Re: Impact Area Groundwater Study Program (IAGWSP), J-3 Range Interim Environmental Monitoring Report – December 2010 through November 2011, dated August 2012

FINAL

J-3 Range

**Interim Environmental Monitoring Report
December 2010 through November 2011**

J-3 Groundwater
Potentiometric Map for
21 September 2011

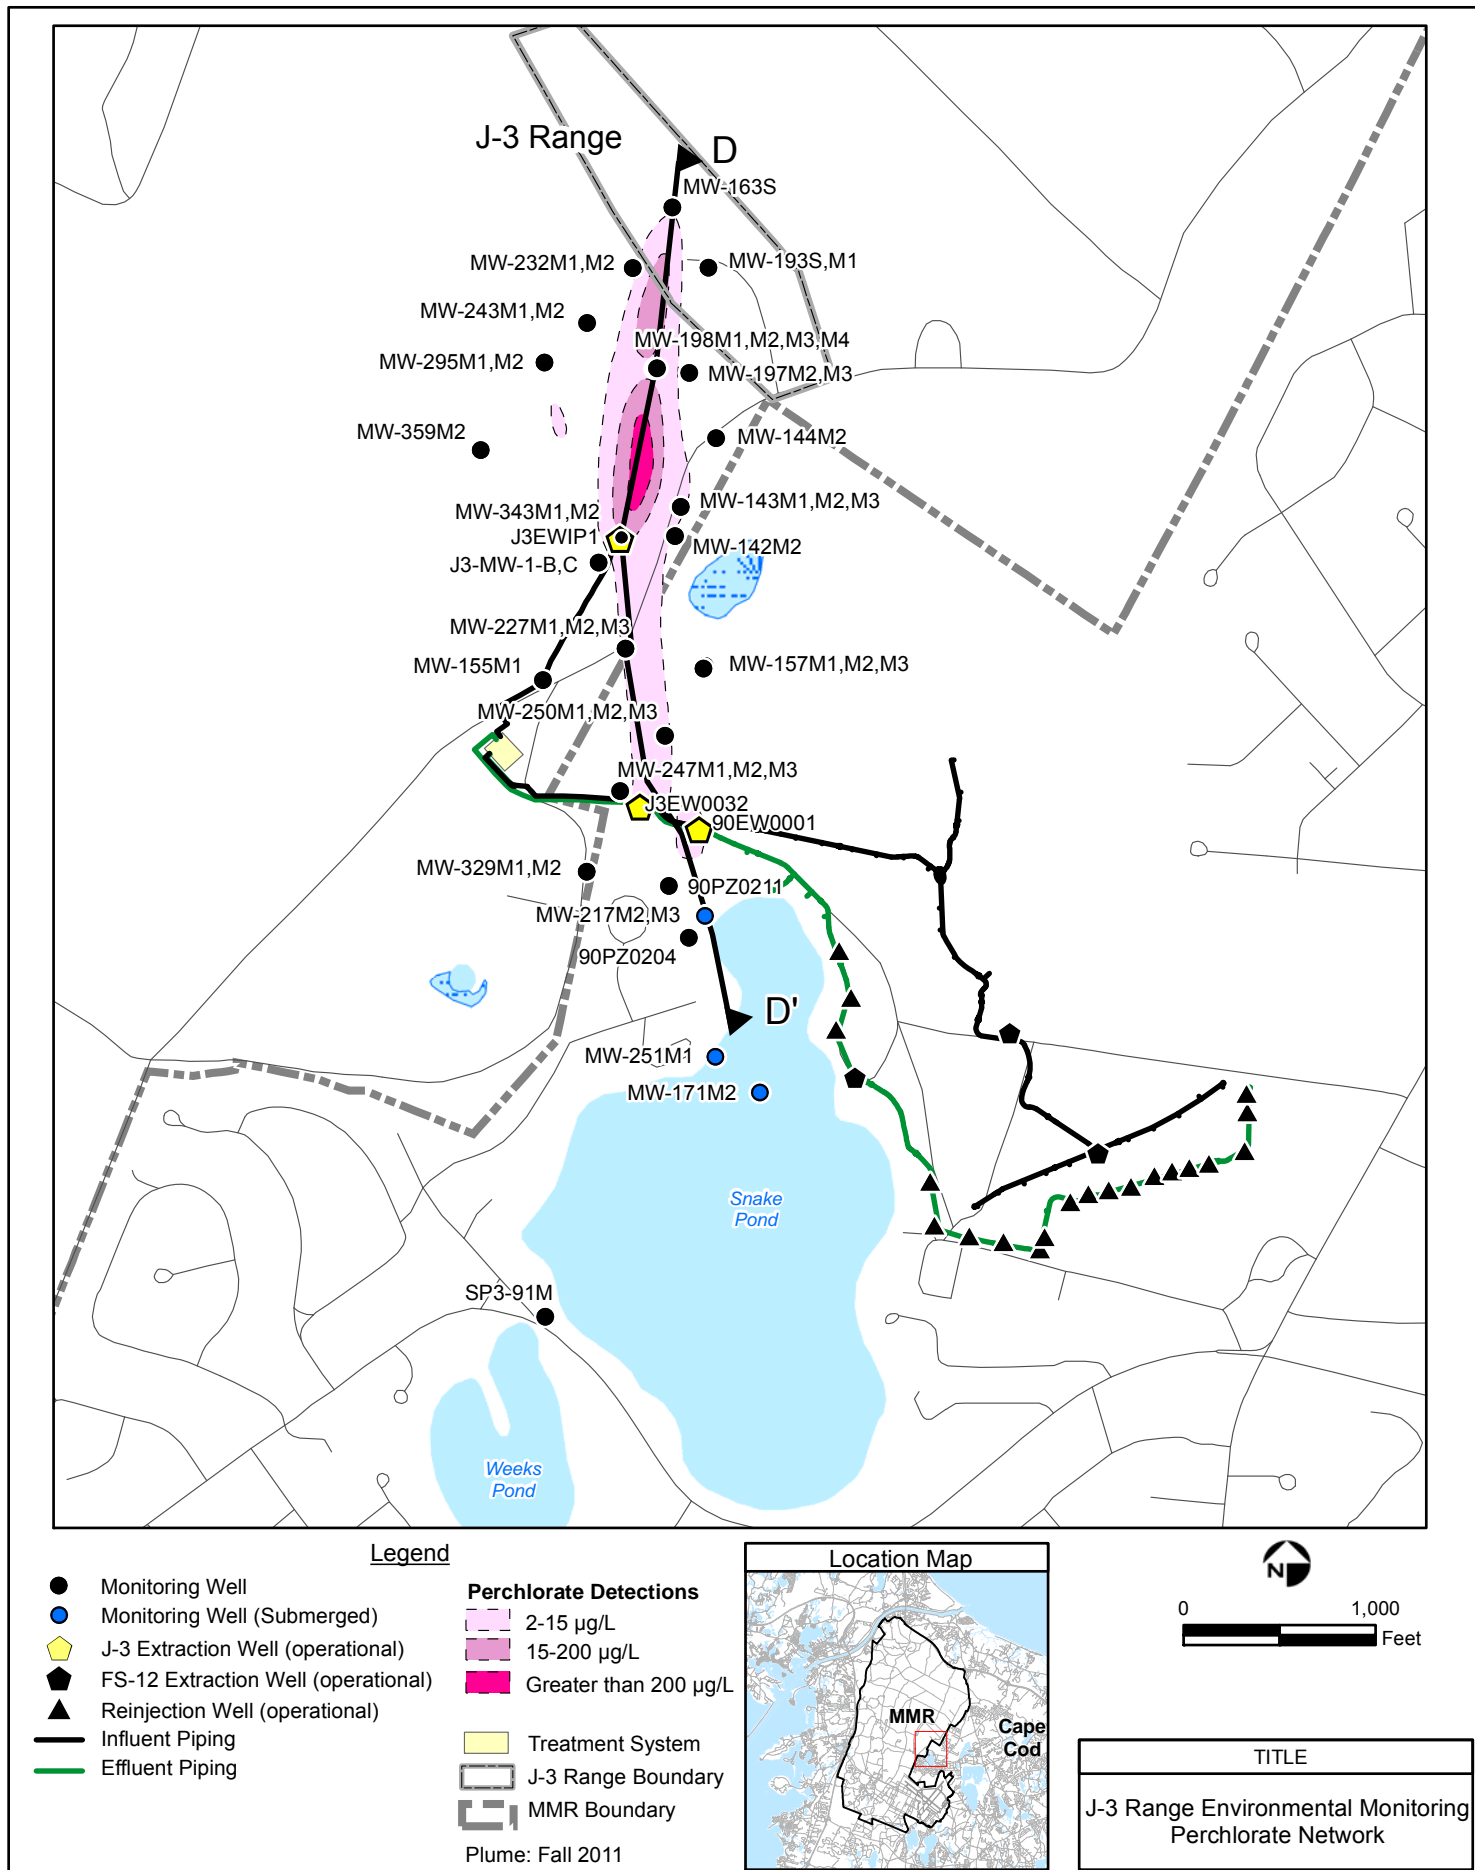
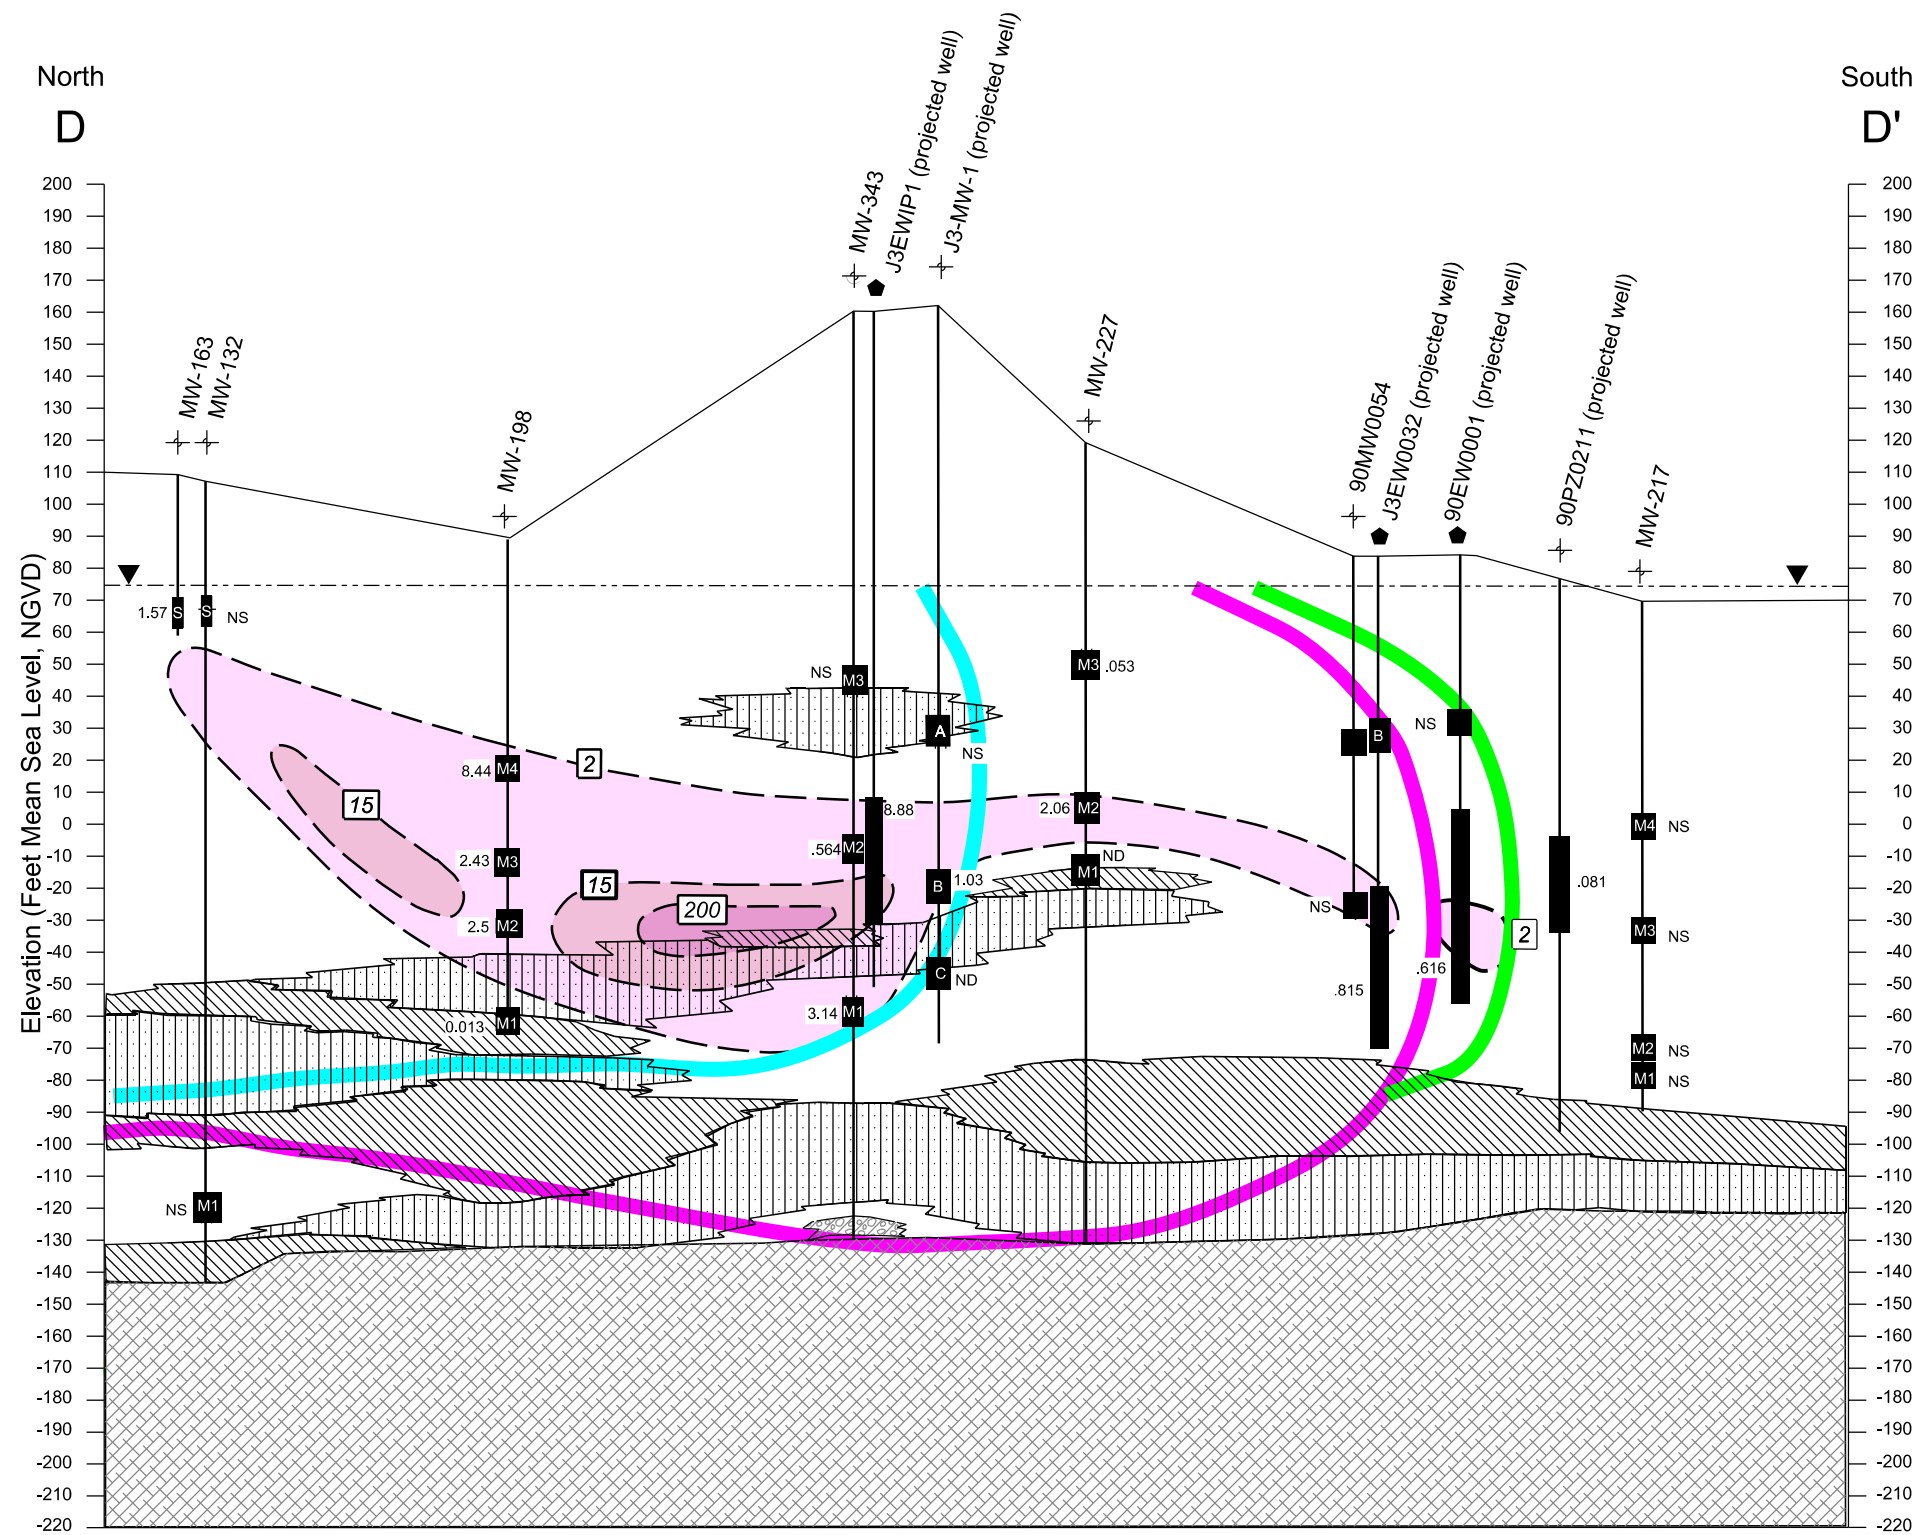
- 2) Pg 4-1, §4.2 - The potentiometric surface and groundwater flow vectors for J-3 groundwater based on September 2011 water-level data is presented in Figure 4-2. When discussing the depicted potentiometric surface, the monitoring report indicates that "the water levels reported for the MW-227 well cluster were anomalously high suggesting a J3EWIP1 stagnation zone that is much farther downgradient than expected." The MW-227 cluster is recommended for survey to verify the reported water-level measurements. The monitoring report (pg. 4-2) further indicates that the "downgradient stagnation point of the J3EWIP1 extraction well lies north of the MW-227 well cluster and that "groundwater downgradient of MW-227 wells continue to move southward and converges on either well J3EW0032 or 90EW0001." However, inspection of the potentiometric surface depicted in Figure 4-2 indicate that the water levels observed in the MW-227 are indicative of a potential area of bypass west of and around the capture zone created by J3EWIP1. This area of likely bypass is in the immediate vicinity of and west of the J3-MW-1 cluster. Groundwater in this area appears to flow southeastward toward the MW-227 cluster. Furthermore, at the MW-227 cluster, a significant component of flow towards the east and southeast, rather than the south, is evident. Based on the potentiometric surface and flow vectors depicted on Figure 4-2, a significant component of flow may pass eastward past the MW-157 cluster. Groundwater flow passing to the east of the MW-157 cluster may pass beyond the apparent capture zone created by 90EW0001. While groundwater quality data does not currently appear to indicate that groundwater contamination is migrating past the MW-157 cluster, there are potential inadequacies in the current monitoring network that may not allow the detection of contaminant migration in this area (see Specific Comments Nos. 4 and 5). Moreover, additional

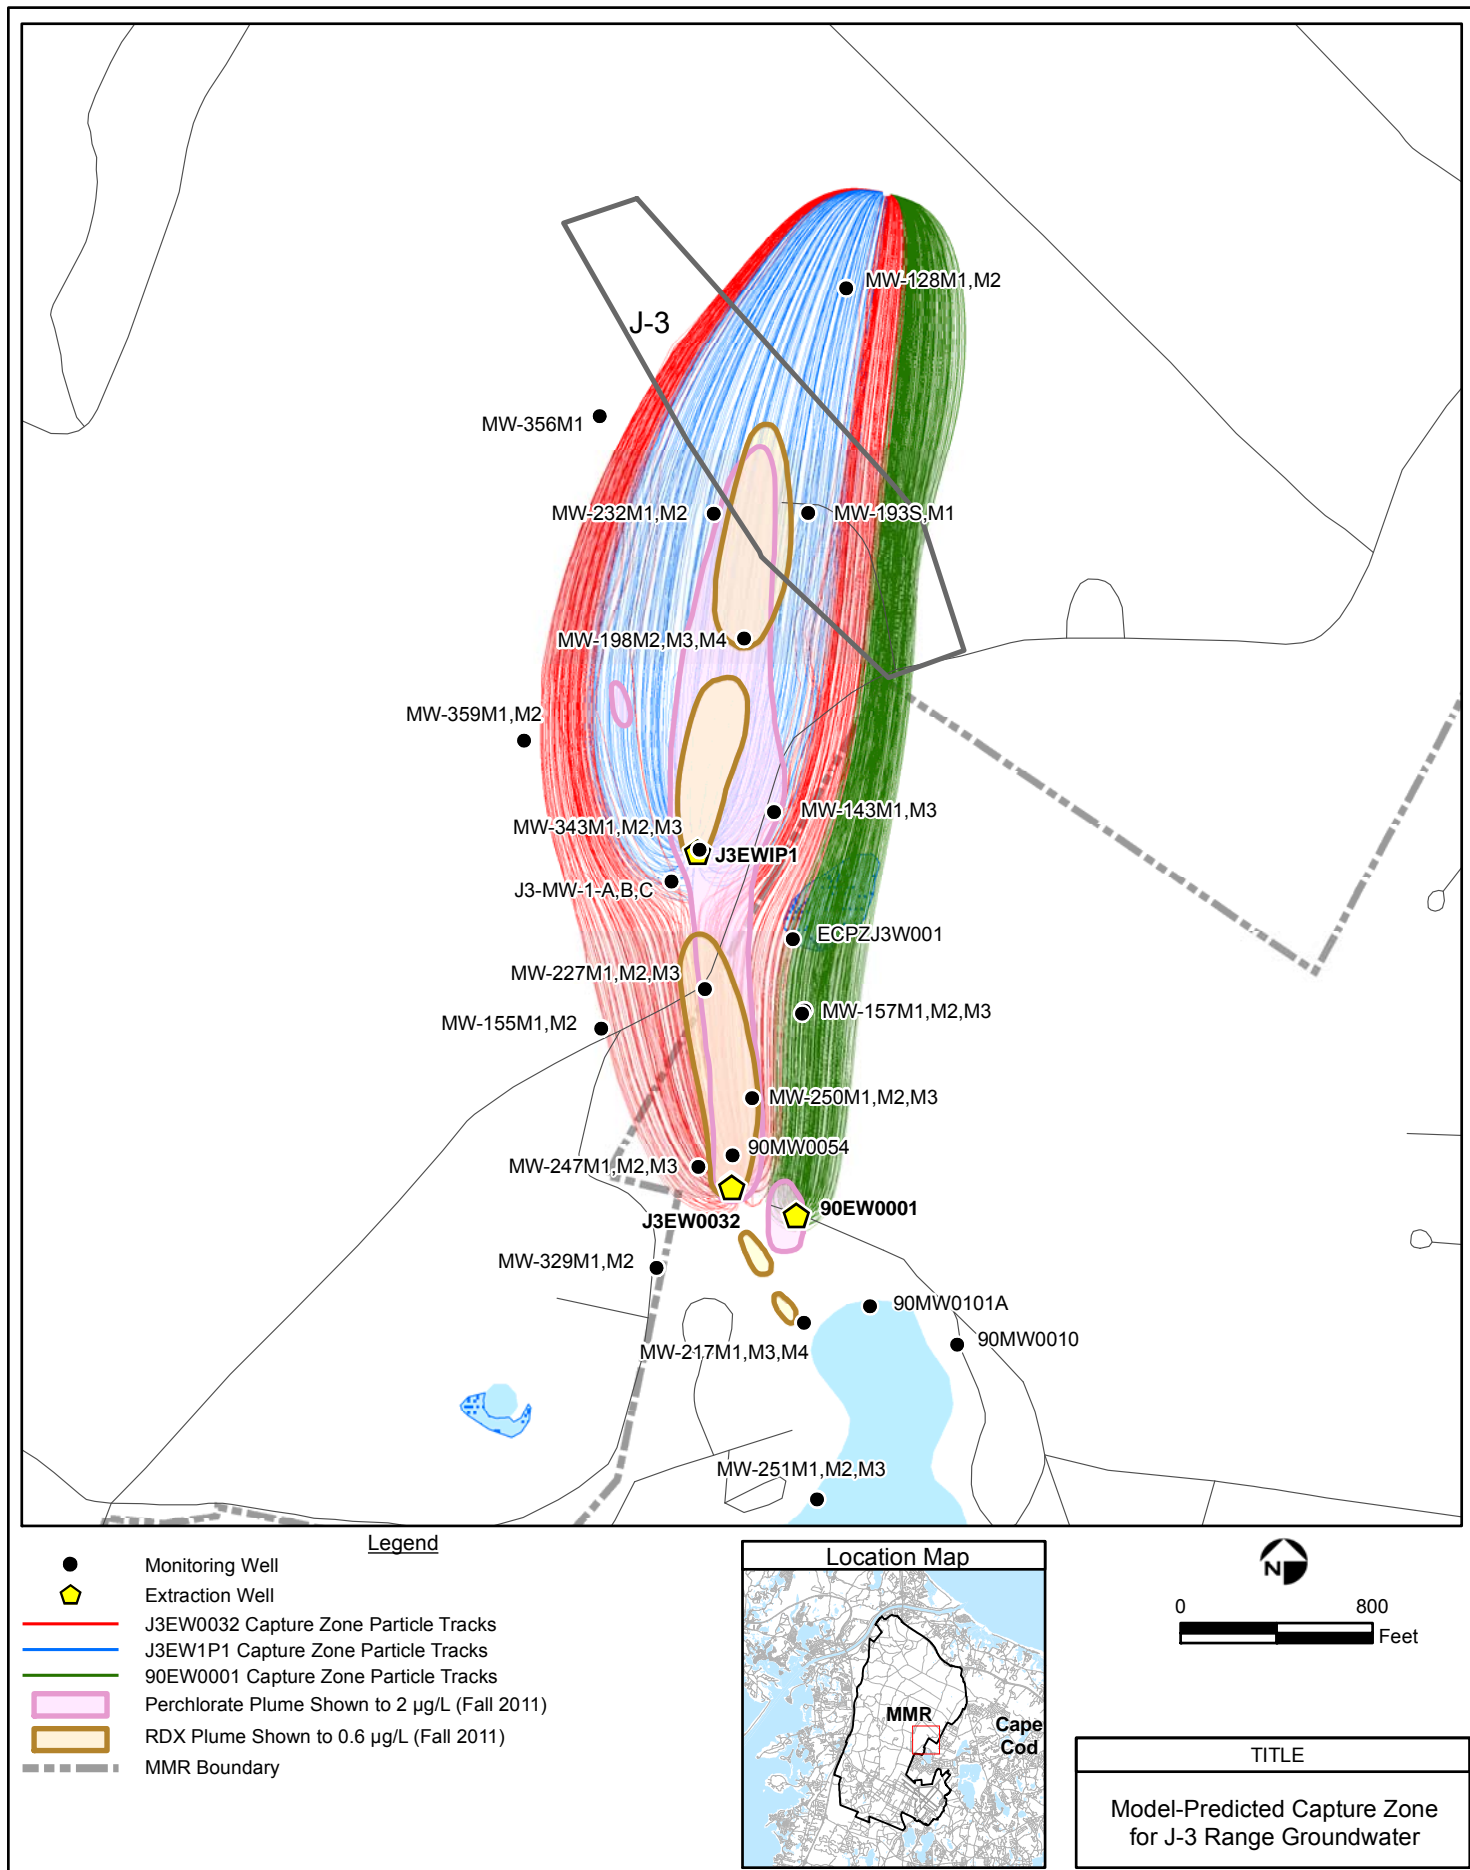
- 2) The capture zones for the individual extraction wells in the J-3 area are presented in Figure 6-8. The monitoring report indicates that these capture zones were developed using particle tracking and the calibrated model for the J-3 area. The text further indicates that the model was calibrated based on the base scenario, which consisted of the regional model calibrated to the 2003 (non-system) conditions, but simulating the 2011 injection/extraction rates. However, the particle tracks presented in Figure 6-8 do not appear to reflect the flow anomalies recently observed downgradient of extraction well J3EWIP1 in the area of the MW-227 cluster and extending eastward towards the MW-157 cluster as well as northeastward toward the MW-142 well cluster (see Specific Comment No. 1). Thus, the capture zones depicted in Figure 6-8 do not appear to reflect current conditions at the site.
